Project Title: Entertainment Facility **Building Permit #:** _____ **Hydrology File #:** _____

**RE: ENTERTAINMENT FACILITY
3930 PAN-AMERICAN NE
GRADING AND DRAINAGE PLAN
ENGINEERS STAMP DATE: 2/16/18
HYDROLOGY FILE: G16D145A**

GRADING PLAN

SHEET #
3

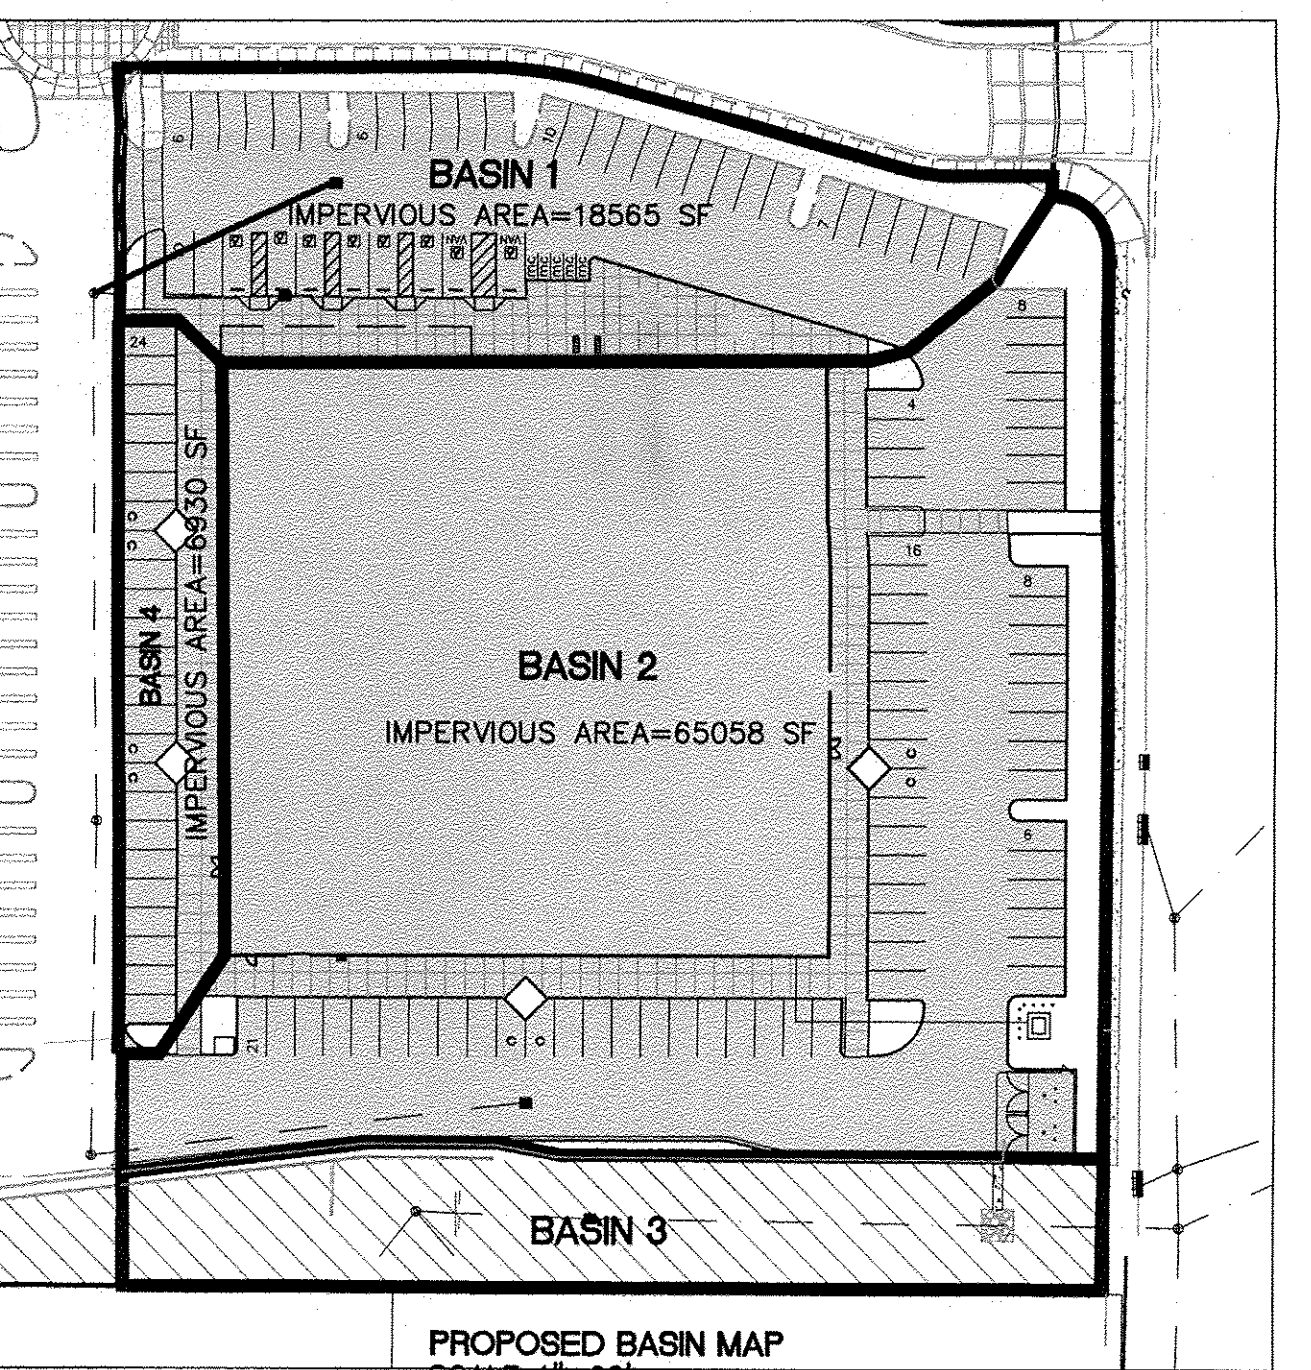
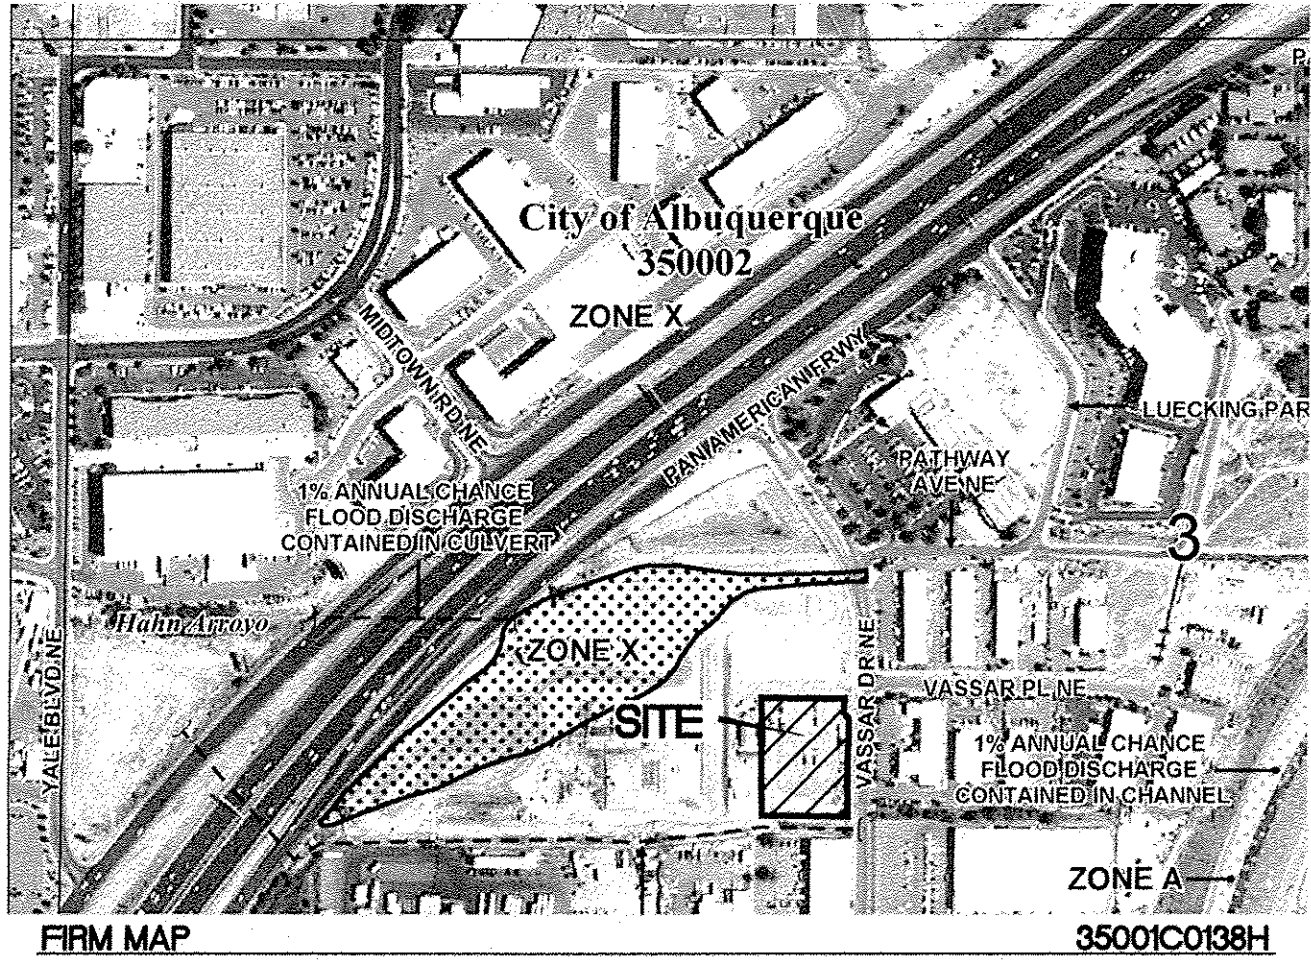
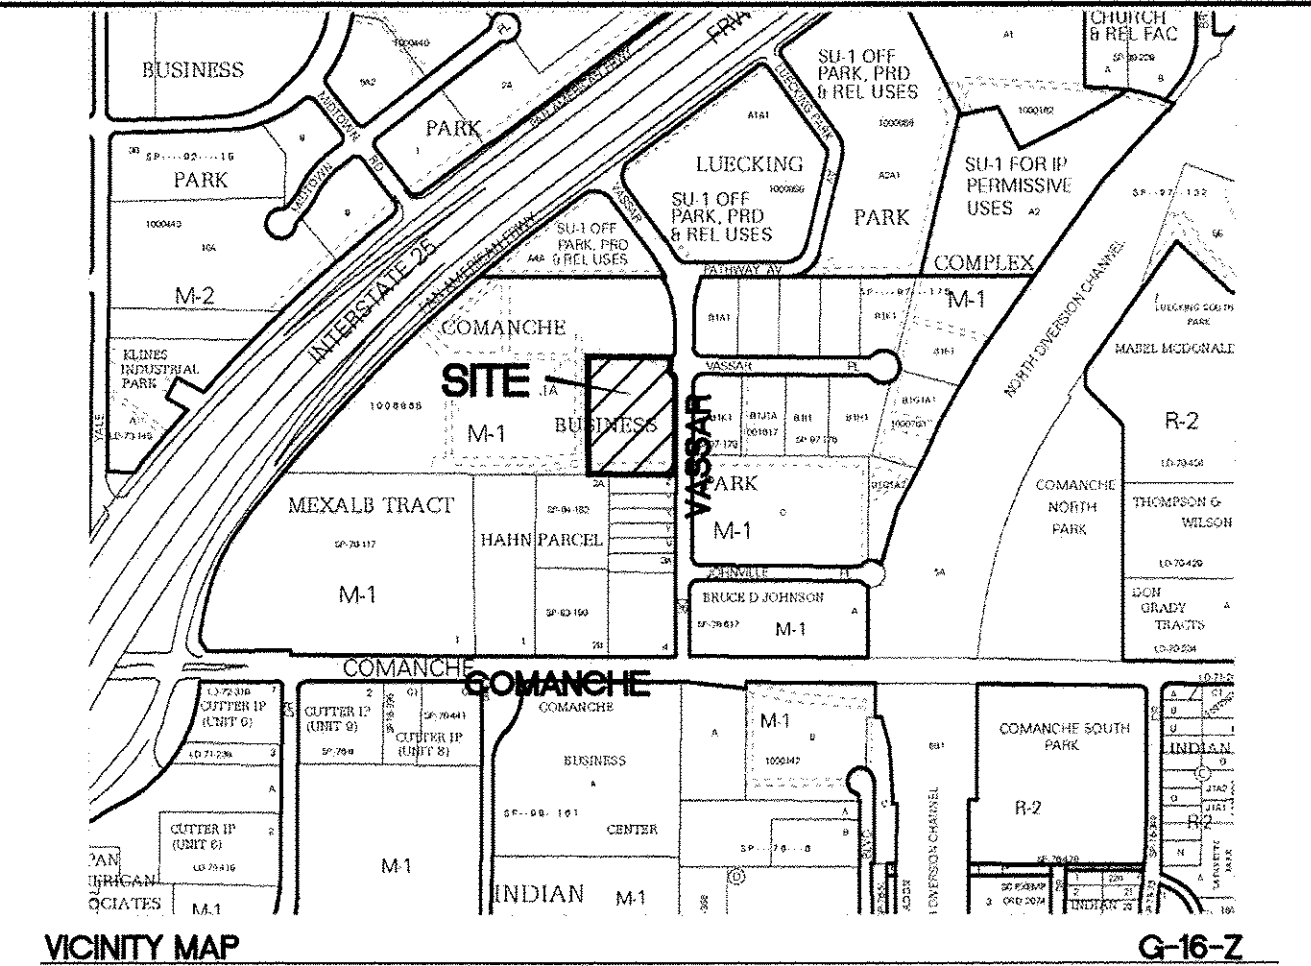
6. Additional detail will be needed for the pond(s), including top of pond elevations, actual and required volume and water surface elevations with respect to walls and property lines.

A cross-section of the channel was added to Sheet 3.
